MIDWEST POOLED FUND PROGRAM

**Progress Report
First Quarter 2009
January 1st to March 31st (Actually Through April 20th)
Midwest Roadside Safety Facility
Nebraska Transportation Center
University of Nebraska-Lincoln**

Pooled Fund Consulting Summary

Figure 10. Wisconsin Road Closure Gate

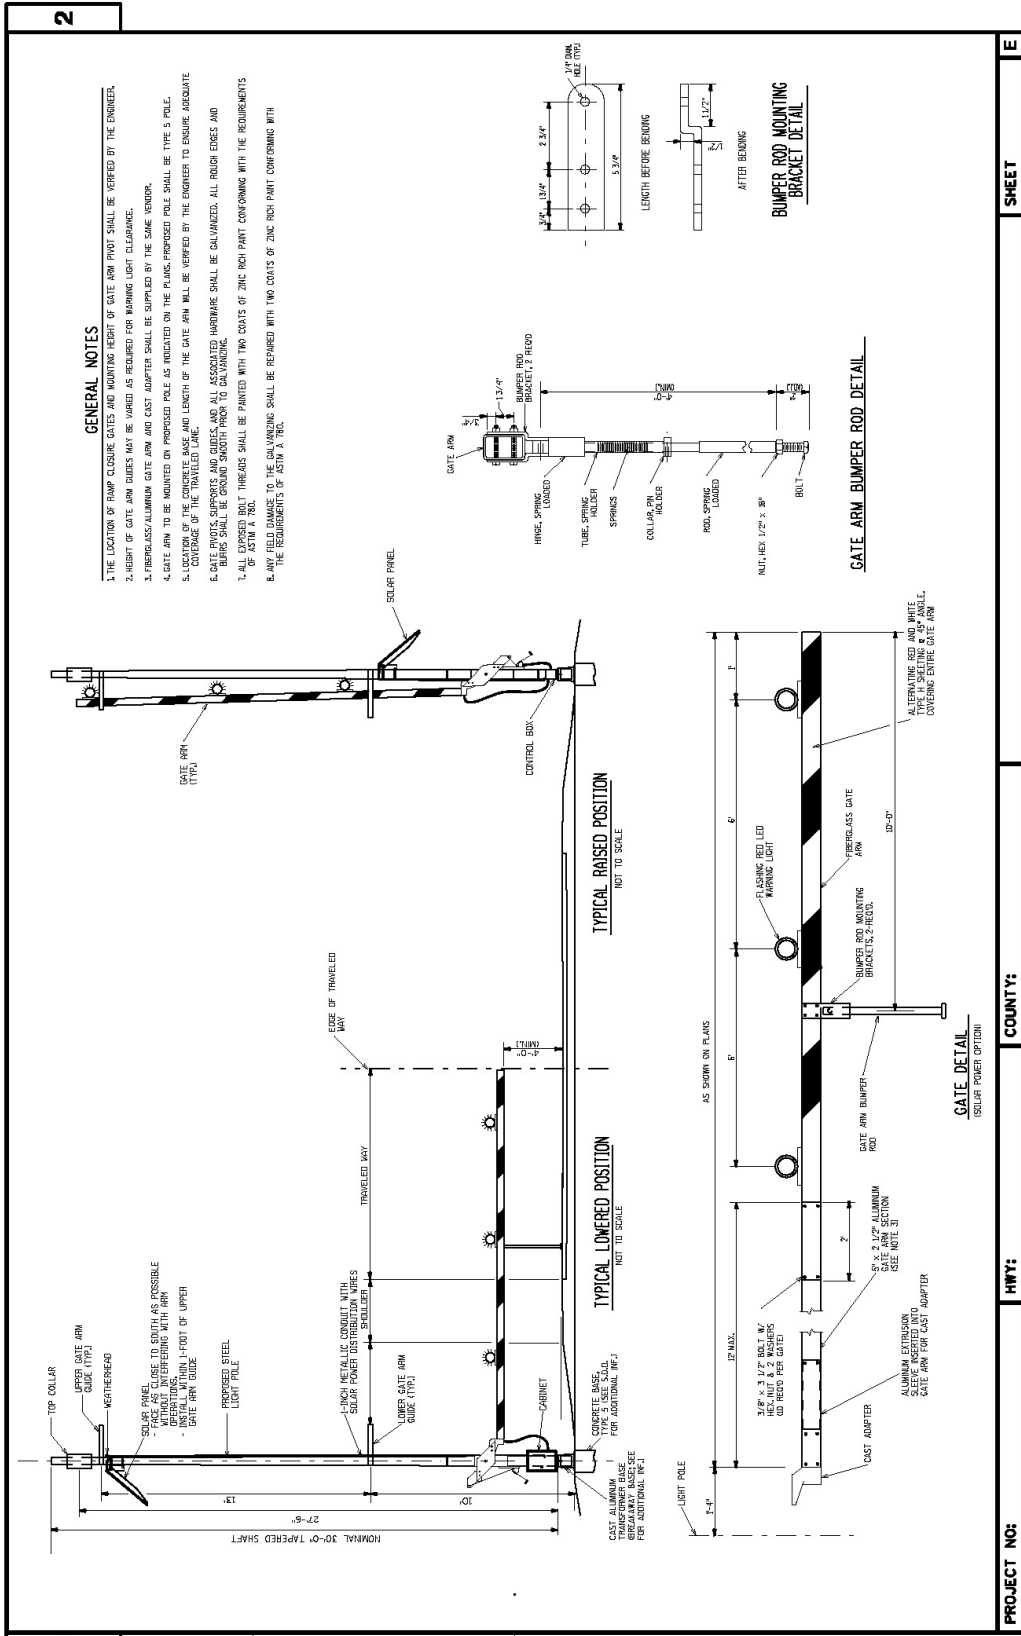
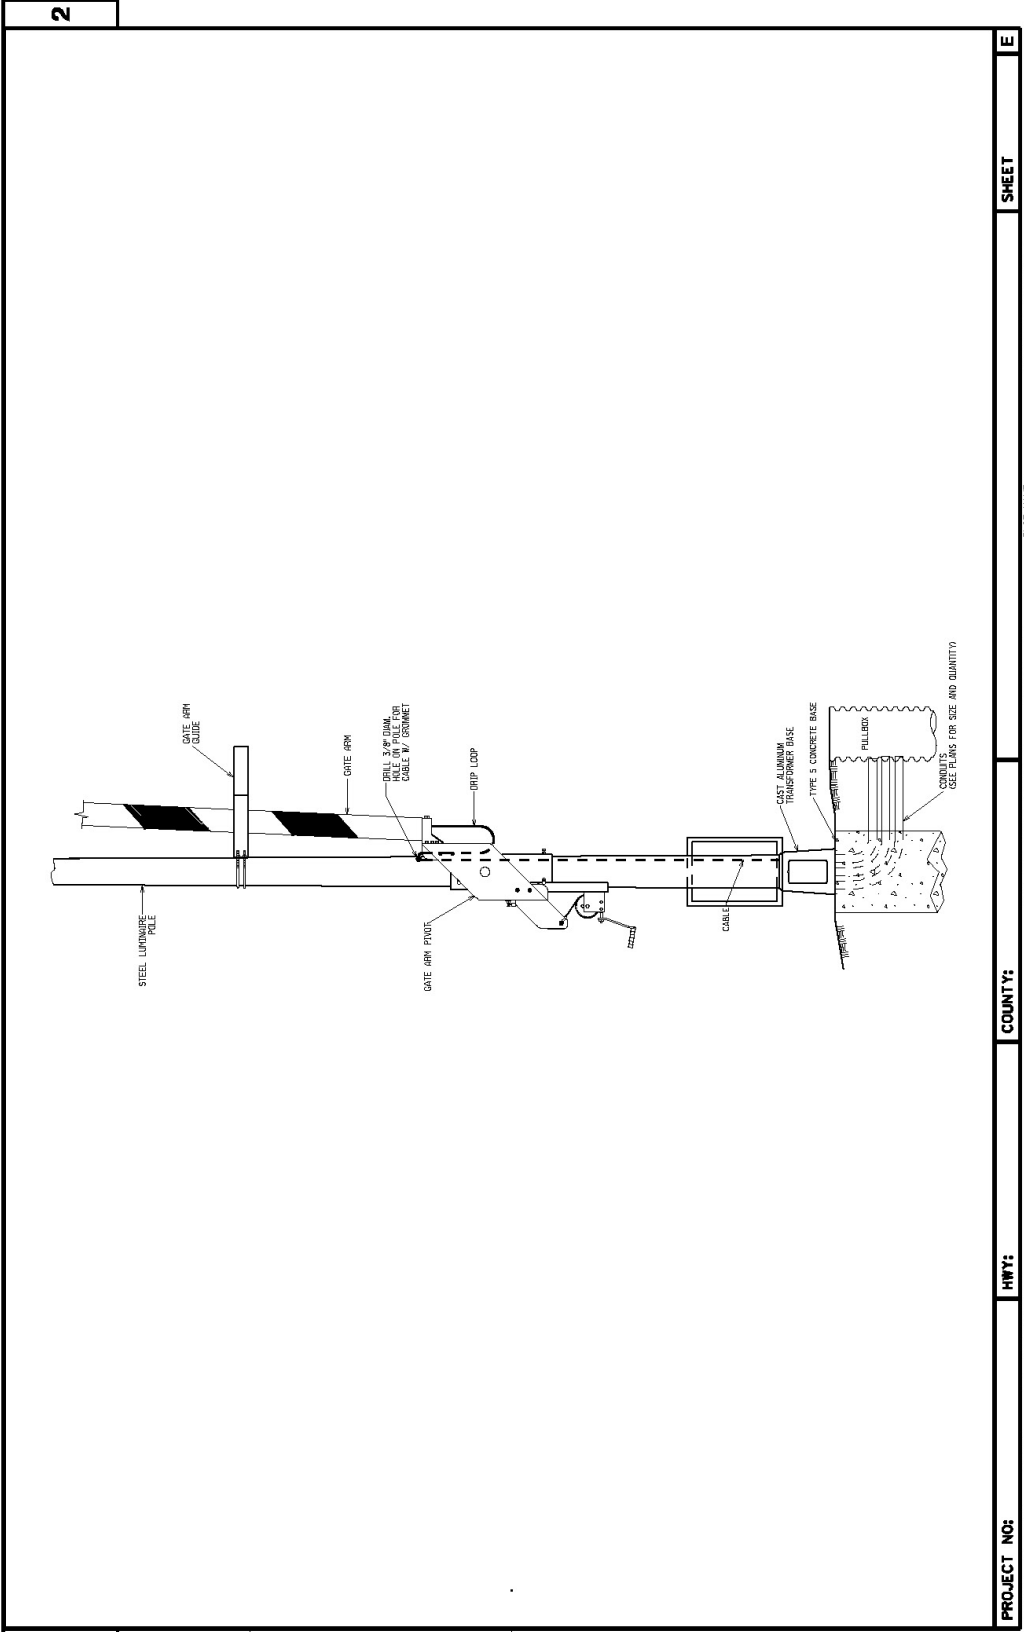
The last design that came from Wisconsin DOT is attached in PDF form. It incorporates a slightly larger pole, solar panel, control cabinet, and a steel collar near the top to replace the light. However, in order to satisfy the C.G. height requirement the weight of the collar must be increased from 83 pounds (as shown) to 141 pounds. The mass moment of inertia is satisfactory. More details are available upon request.

The breakaway mechanism at the base of the pole was also being changed. The behavior of the pole/gate may be significantly altered after changing the breakaway mechanism and adding over 200 pounds. Wisconsin was going to run this new design by FHWA to see if the closure gate would still be approved with the different breakaway mechanism as well as the added components.
